Flood Control  
WATER PERMIT NO. FC-4

**Application For Permit To ~~Appropriate Water Within The State Of South Dakota~~**

BRANT LAKE SP-WAY IMPROVEMENT PROJECT

IN RE APPLICATION FOR FLOOD	)	FINDINGS OF FACT,
CONTROL PERMIT NO. 4	)	CONCLUSIONS OF LAW
	)	AND FINAL DECISION

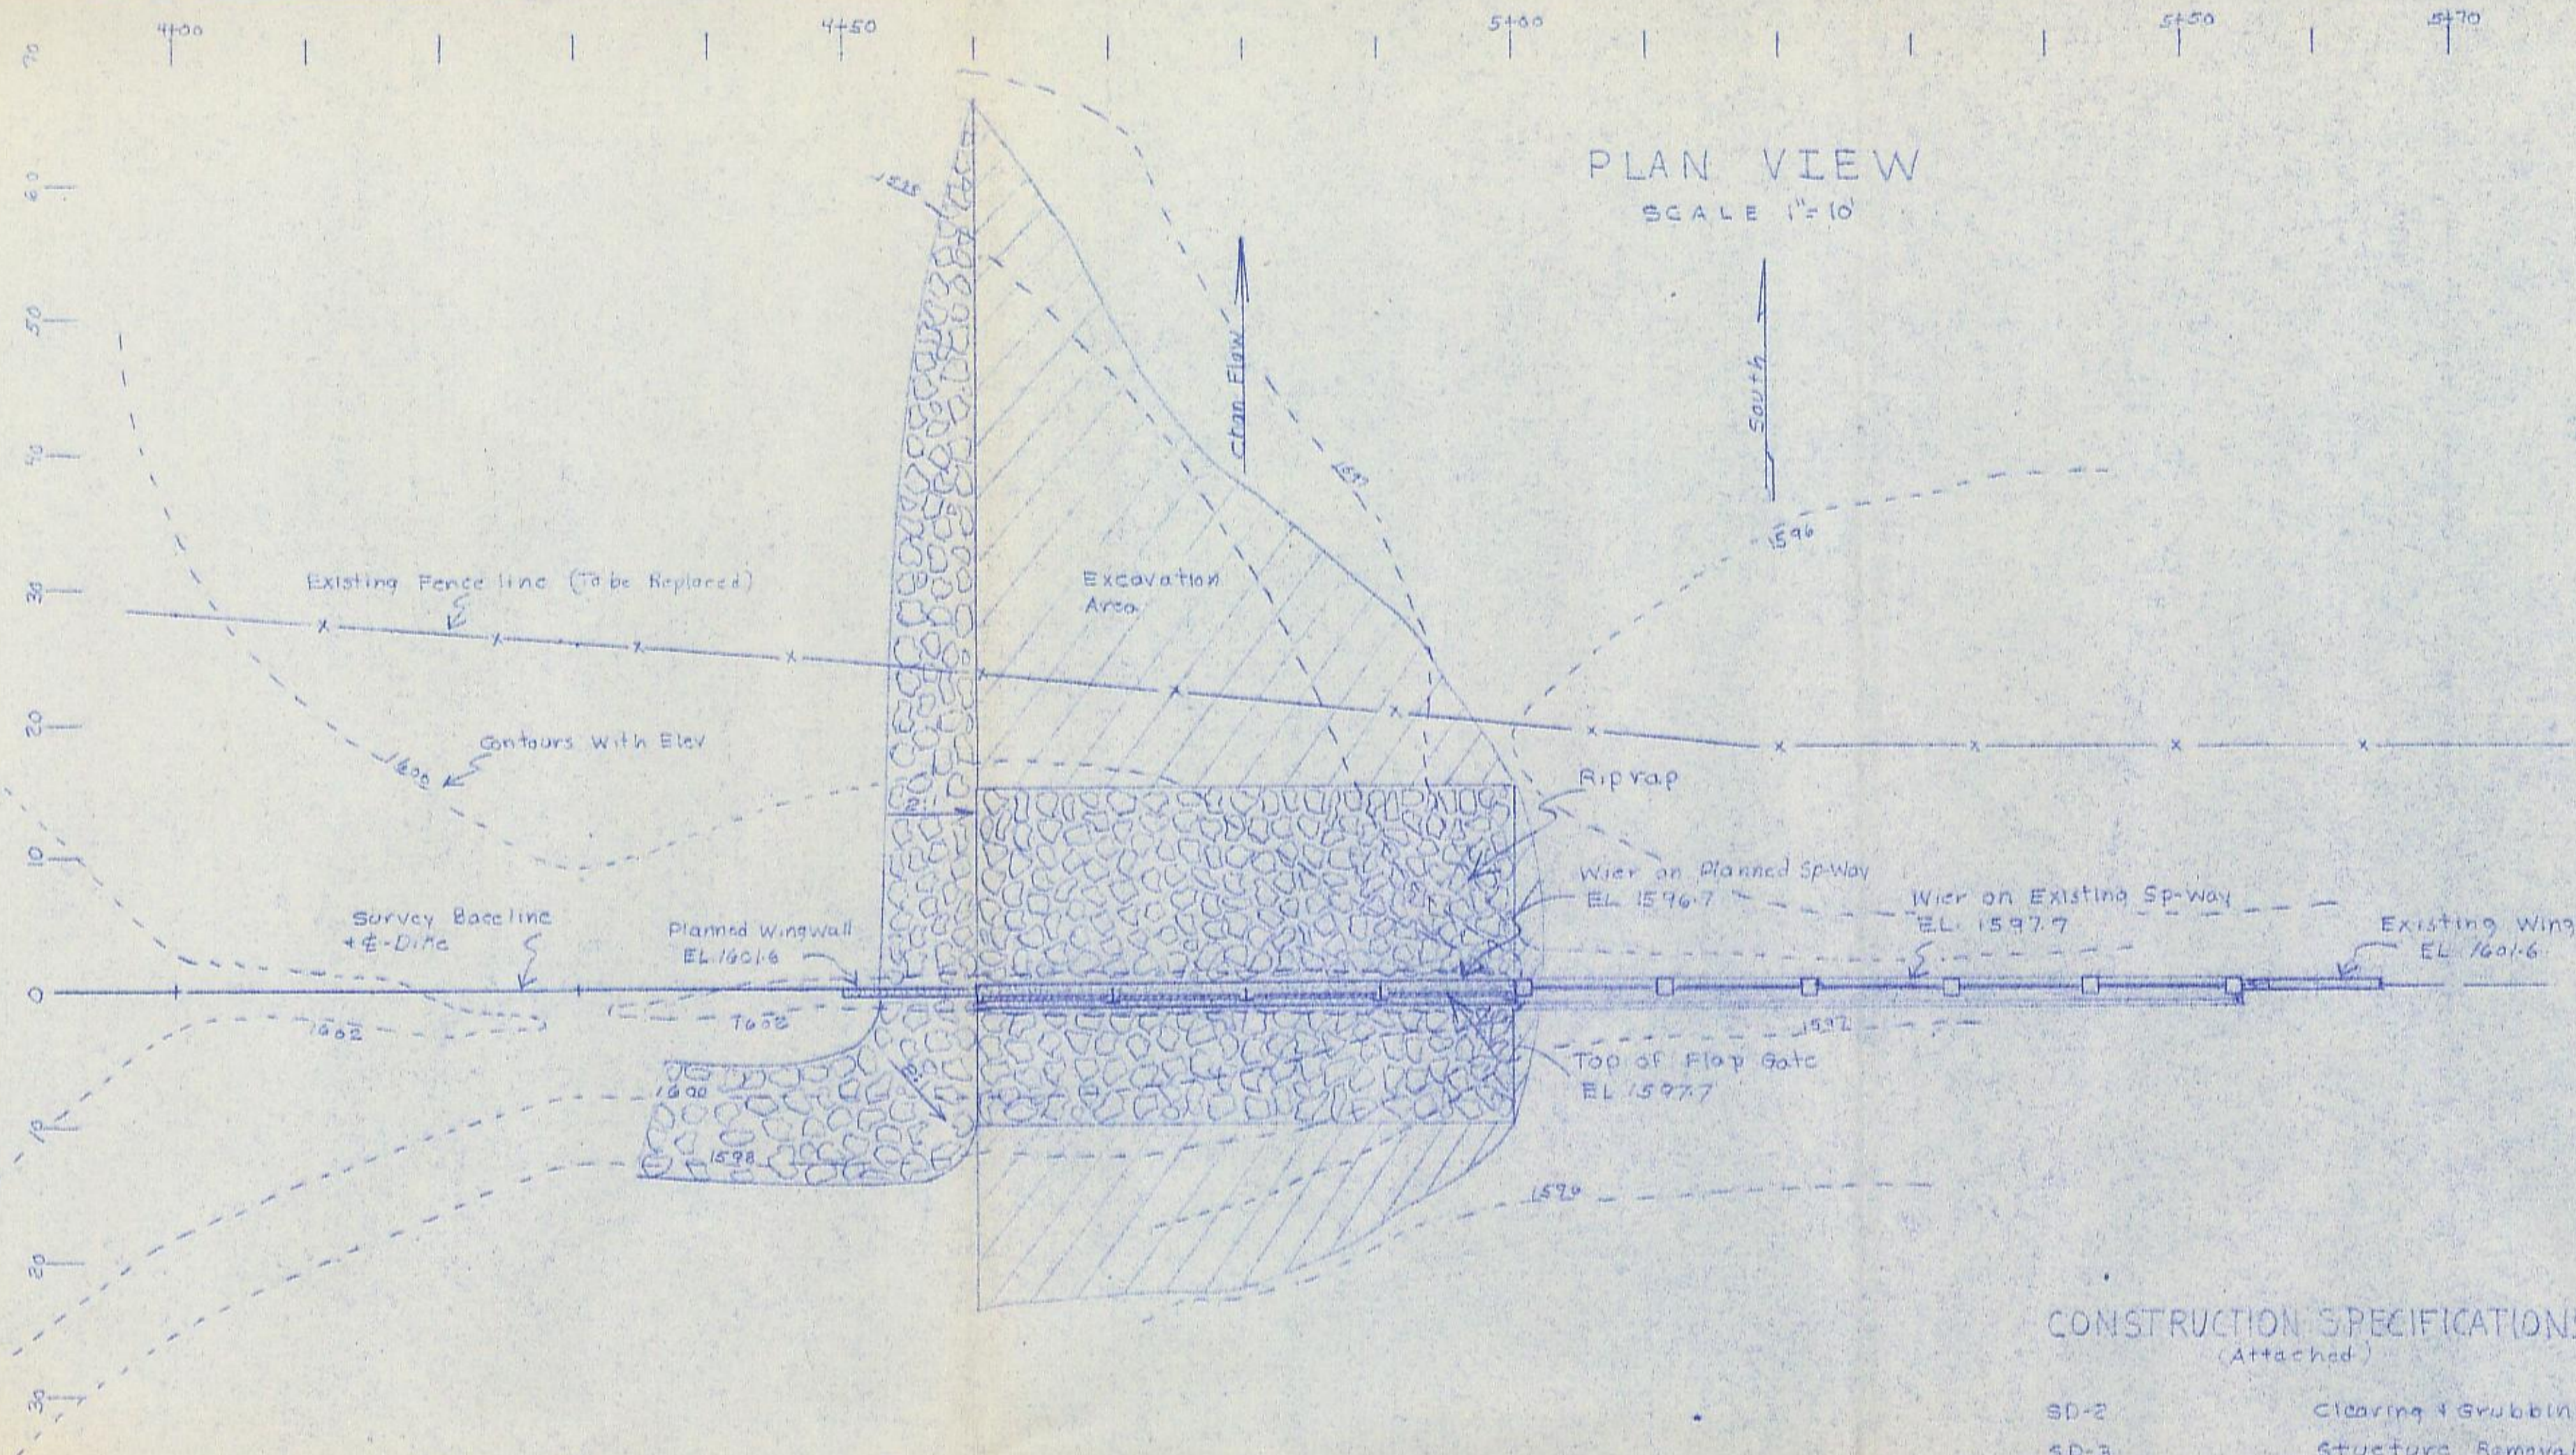
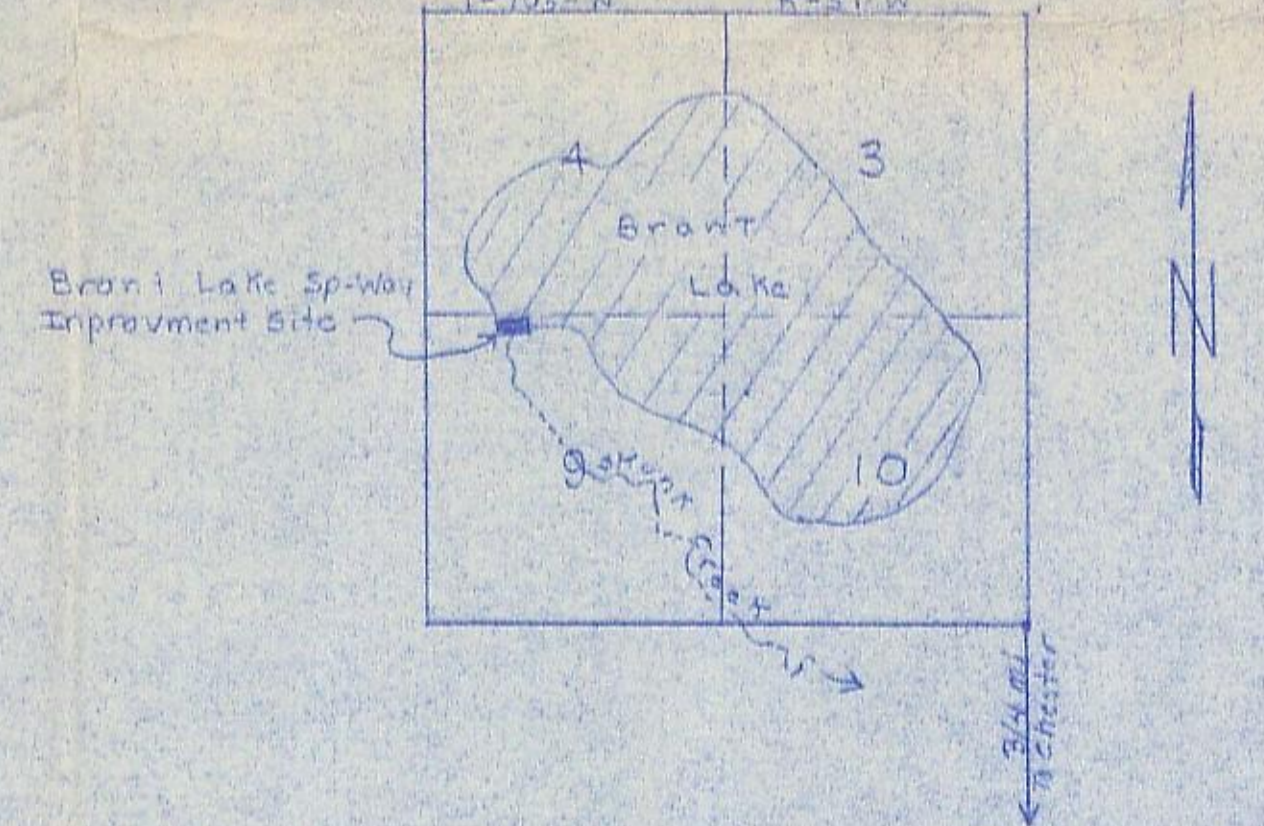
PRIORITY \_\_\_\_\_ Date Received Nov. 6, 1985 Fee 50<sup>00</sup>/<sub>100</sub> Remarks propose to increase lake outlet by 40 feet and lower 40 foot extension by 12 inches below existing outlet elevation

2. Widening the outlet structure by 30 feet and lowering the existing portion of the structure six inches, as proposed in this Application and modification, would significantly decrease damage from erosion and from flooding in the immediate area of the lake.

3. Widening of the outlet structure could cause additional damage downstream if the Flood Control Permit is not conditioned to provide for increased downstream flows.

2. The outlet structure shall be widened by 30 feet and 30 feet of the existing portion of the structure lowered six inches.
3. That the outlet construction, future outlet maintenance and repair will be the responsibility of the Brant Lake Improvement Association.

2. The outlet structure shall be widened by 30 feet and 30 feet of the existing portion of the structure lowered six inches.

(Figure 1)

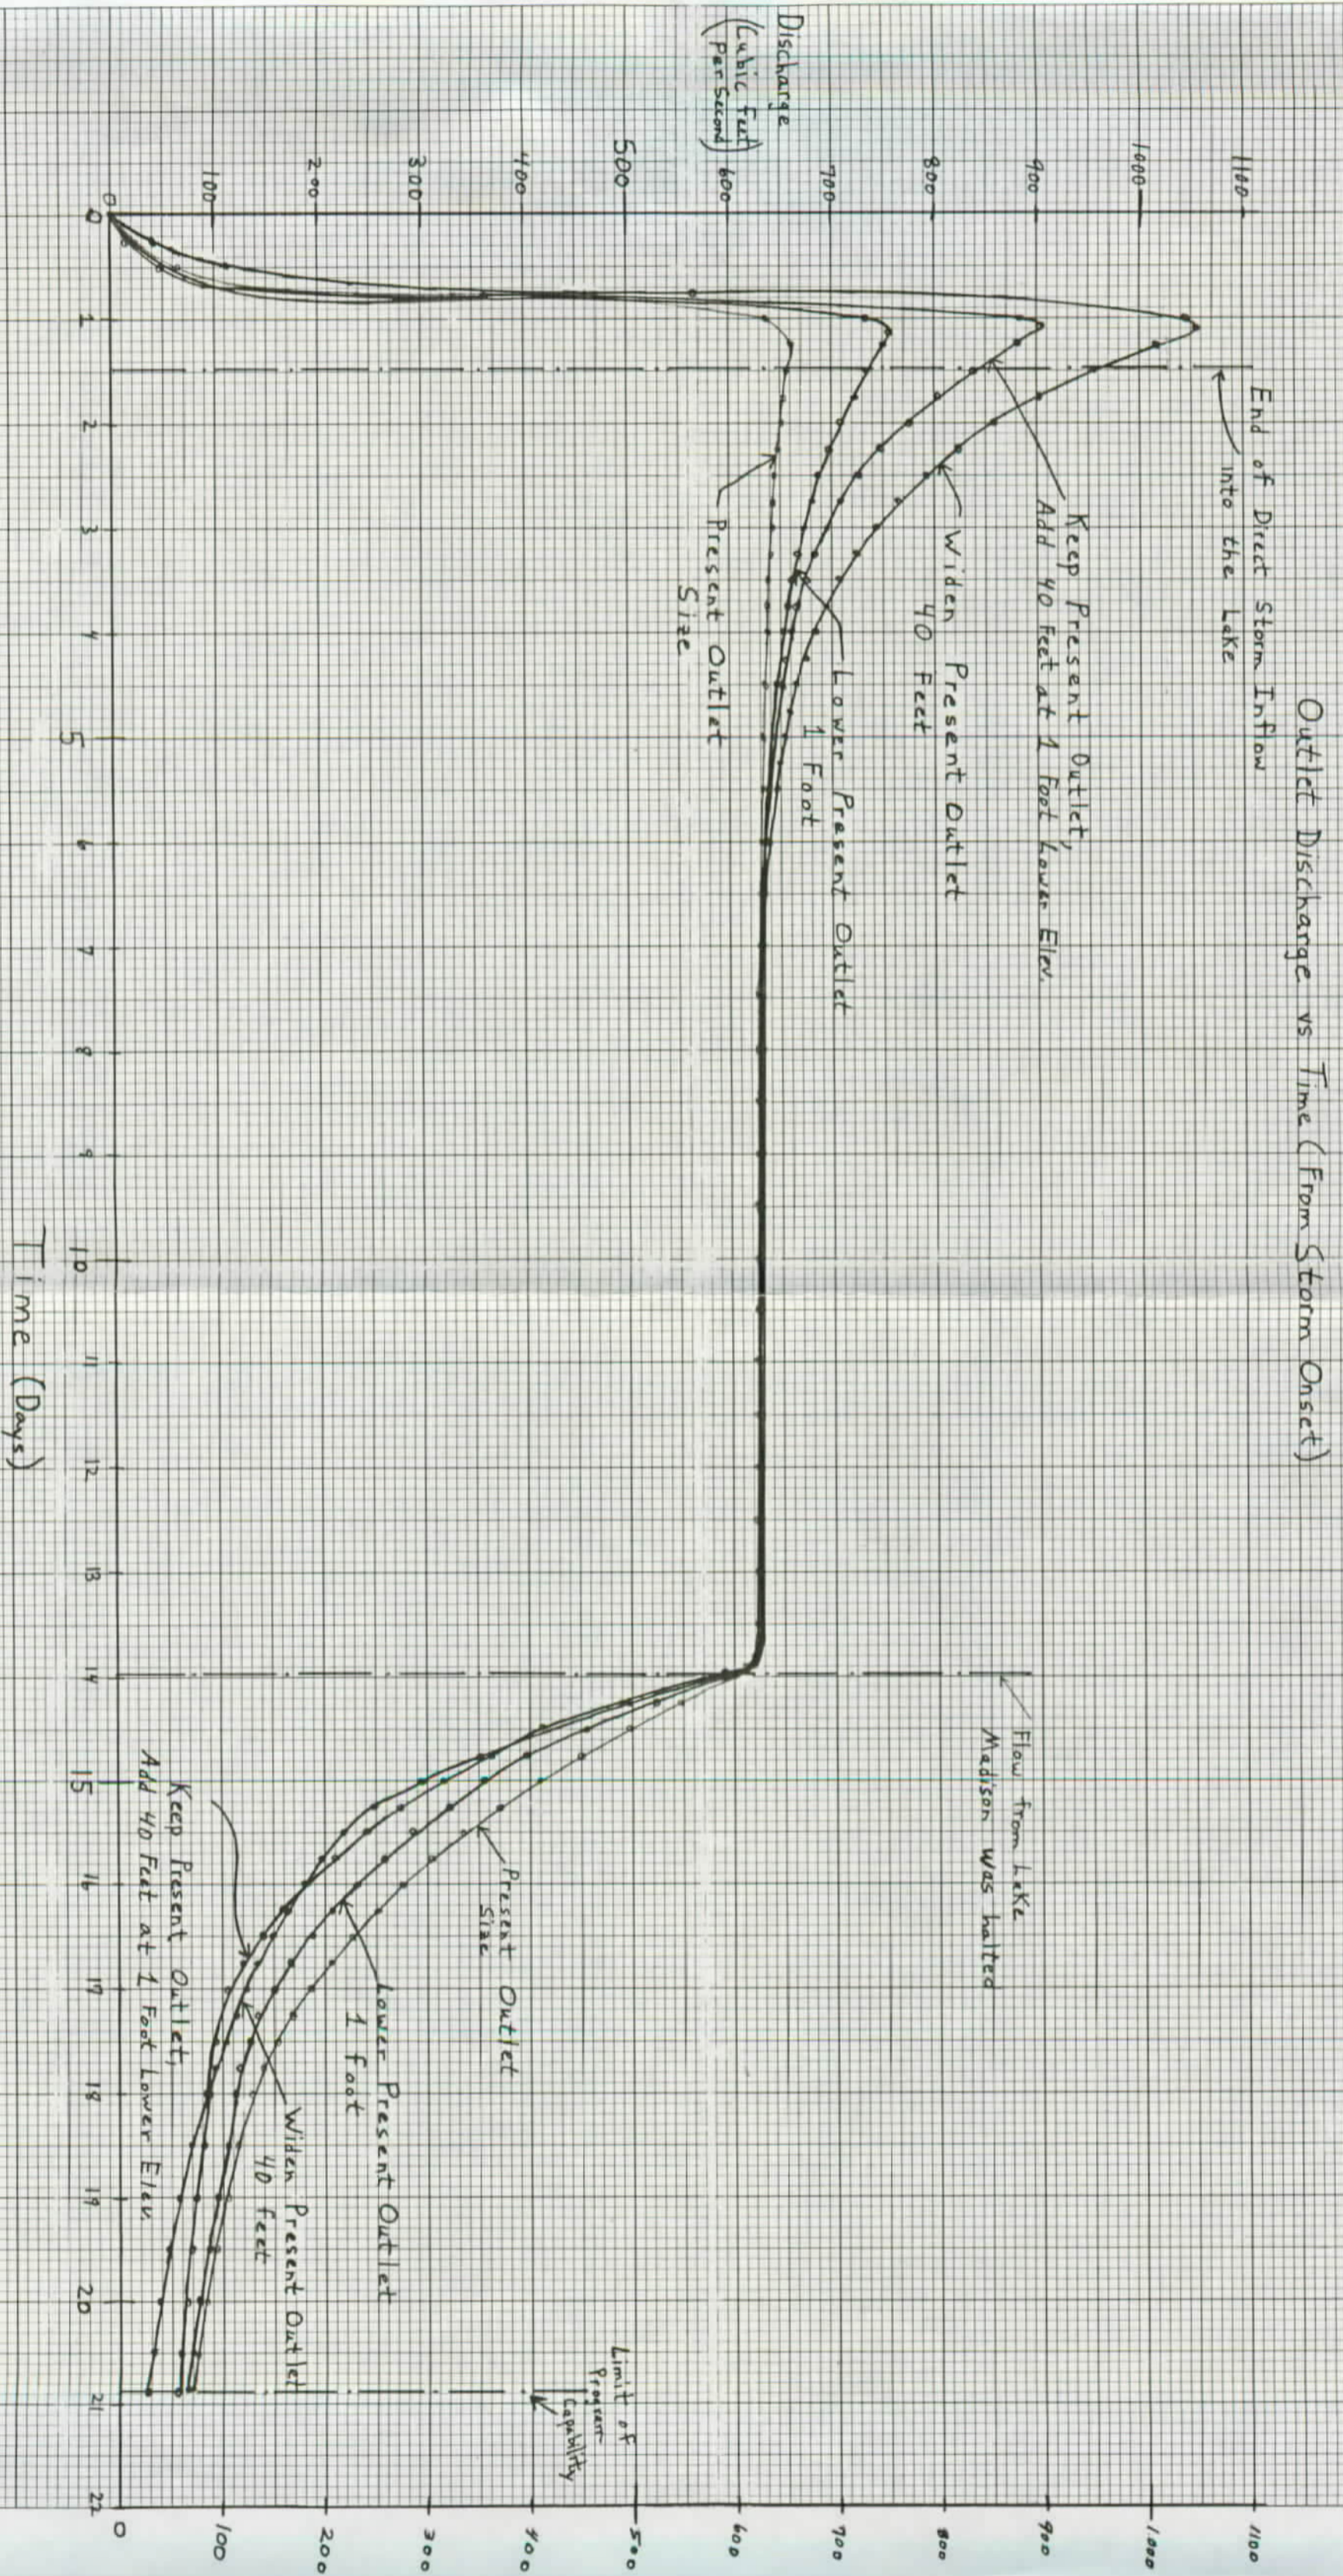
Two according to your projection Brandt Lake was assumed to be full at the beginning of the storm. But you also show a discharge of 625 CFS from Lake Madison. Was this discharge from Lake Madison the unlikely cause of the same storm or had it been discharging at above said rate before the storm. If so why was there no discharge from Brandt Lake at that time?
